**NEXTERA ENERGY POINT BEACH, LLC
POINT BEACH NUCLEAR PLANT, UNITS 1 AND 2**

**LICENSE AMENDMENT REQUEST 261
EXTENDED POWER UPRATE**

NON-PROPRIETARY RESPONSE TO REQUEST FOR ADDITIONAL INFORMATION

December, 2009

Figure 25a: Core Exit Vapor Flow

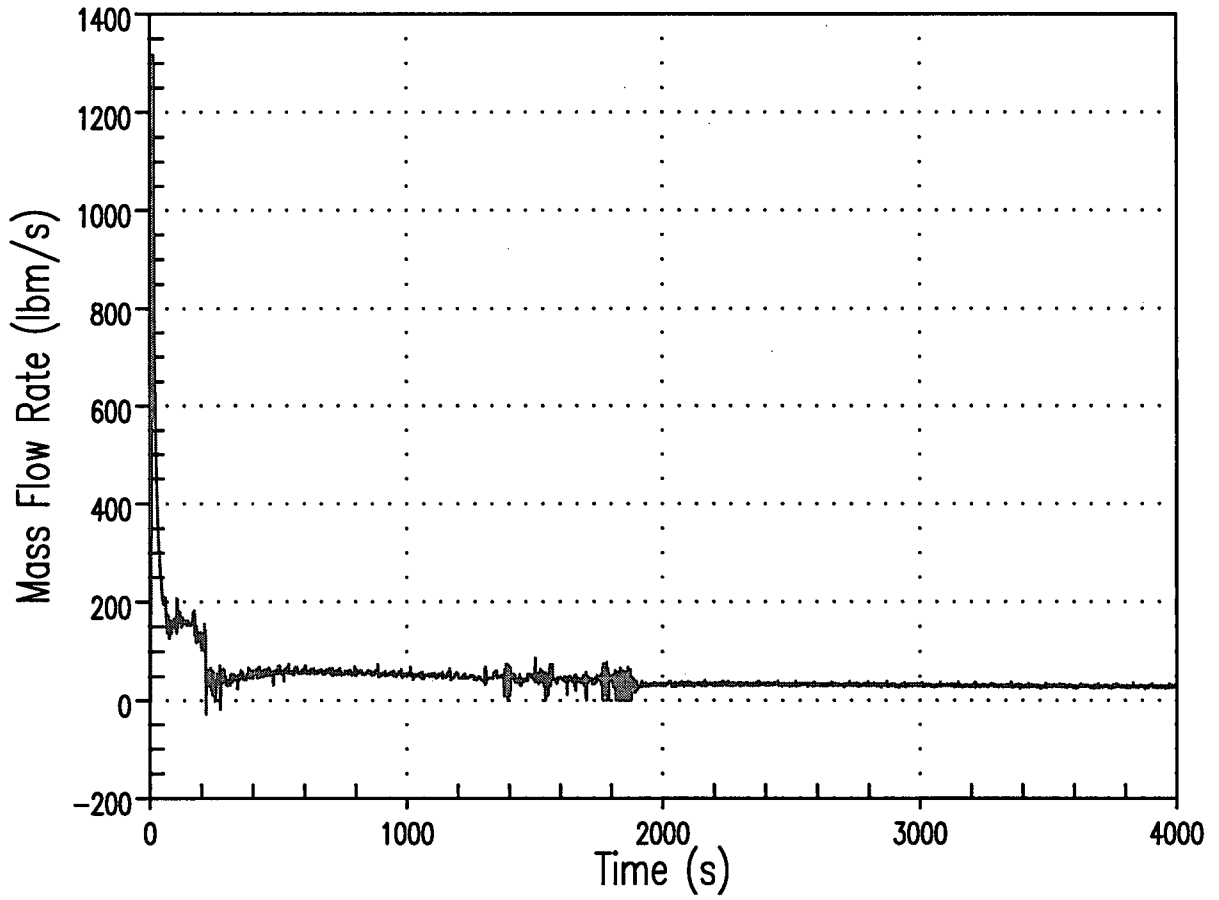
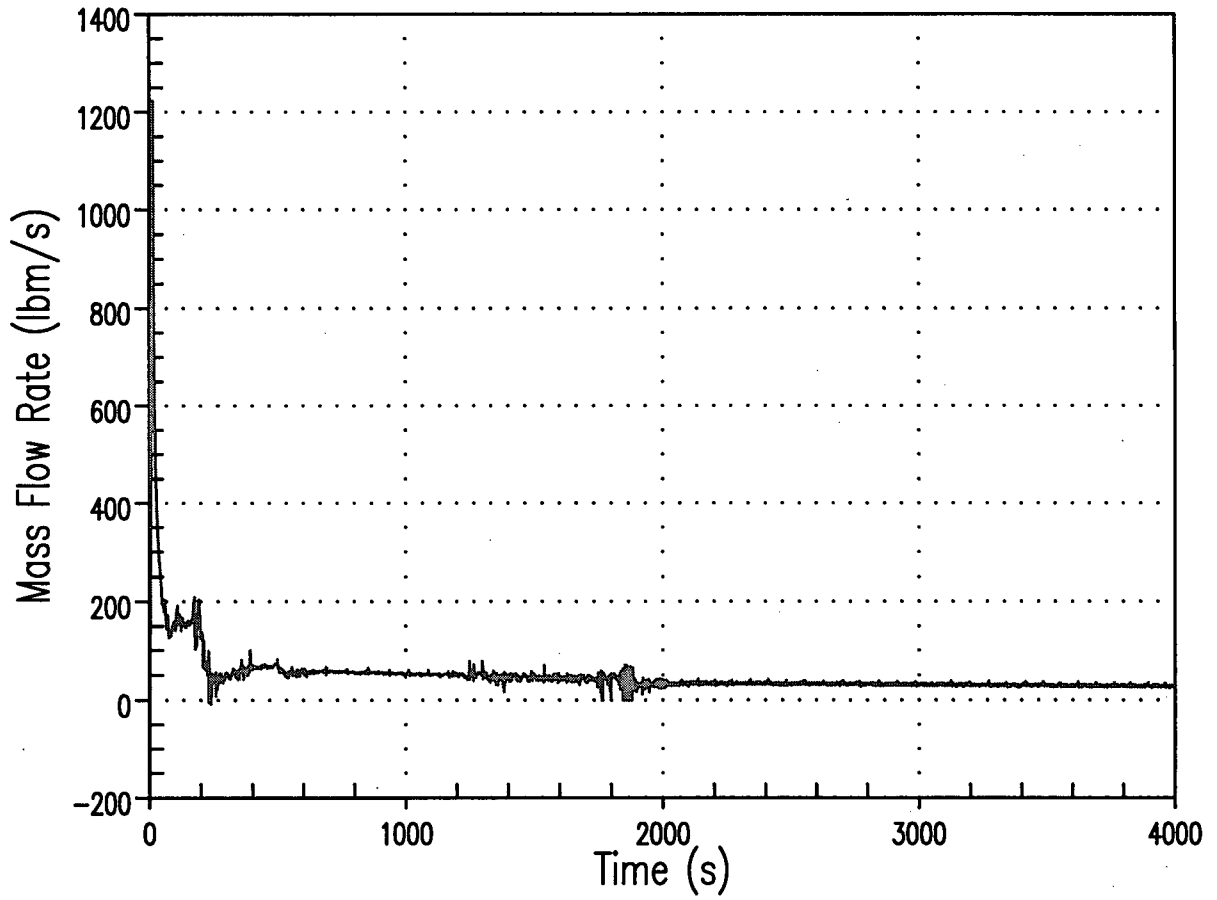
- 1) Page 2.8.5.6.3-6 of the Point Beach Extended Power Uprate (EPU) Licensing Report (Enclosure 5 to Reference 1) indicates that the small-break loss-of-coolant accident analysis was performed using the NOTRUMP evaluation model. Please provide a copy of the NOTRUMP analysis report that supports the EPU application.**

The NRC reviewer provided clarification of this RAI during a teleconference held between Westinghouse, FP&L, and the NRC. It was concluded that the transient response results of the non-limiting breaks, which are not provided in the LAR, will be provided. Transient response results for the limiting 3-inch break for both Point Beach Units 1 and 2 are provided in the small break LOCA LAR Section 2.8.5.6.3. The same response results for the non-limiting breaks are provided below. The following comments apply:

- Peak cladding temperature transients are not provided for the 6- and 8.75-inch breaks as these breaks experienced little to no core uncover.
- Low head safety injection flow figures are provided only for the 6- and 8.75-inch breaks. LHSI was only modeled for the 6- and 8.75-inch breaks (during RWST injection phase only). Breaks less than 6-inches in equivalent diameter did not reach the LHSI cut-in pressure.

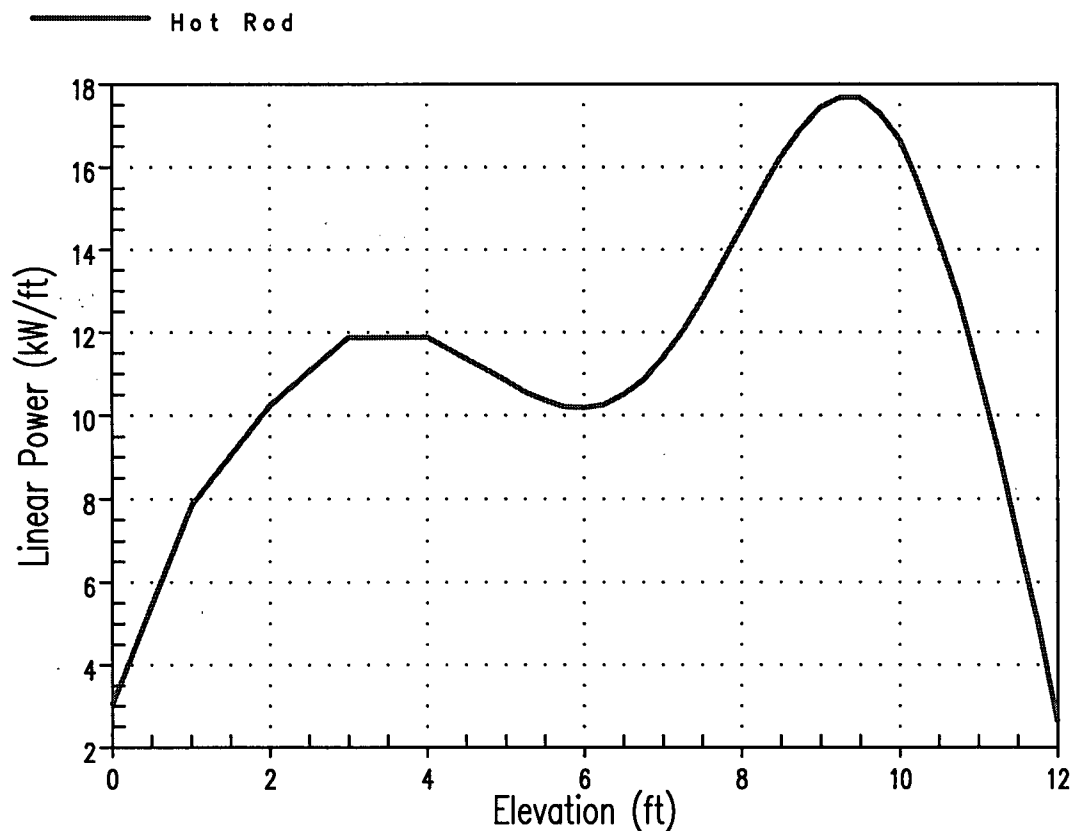
f) **Most limiting top and bottom skewed axial power shapes**

The Point Beach EPU SBLOCA analysis analyzed a limiting top skewed 13% axial offset axial power shape. Bottom skewed power shapes are more favorable in SBLOCA analyses as the core does not uncover to these regions. Further, bottom skewed power shapes result in more voiding and therefore increased core level swell. As such, bottom skewed axial power shapes are not analyzed in SBLOCA analyses.

The hot rod axial power shape analyzed in the Point Beach EPU SBLOCA analysis is provided in the figure below.
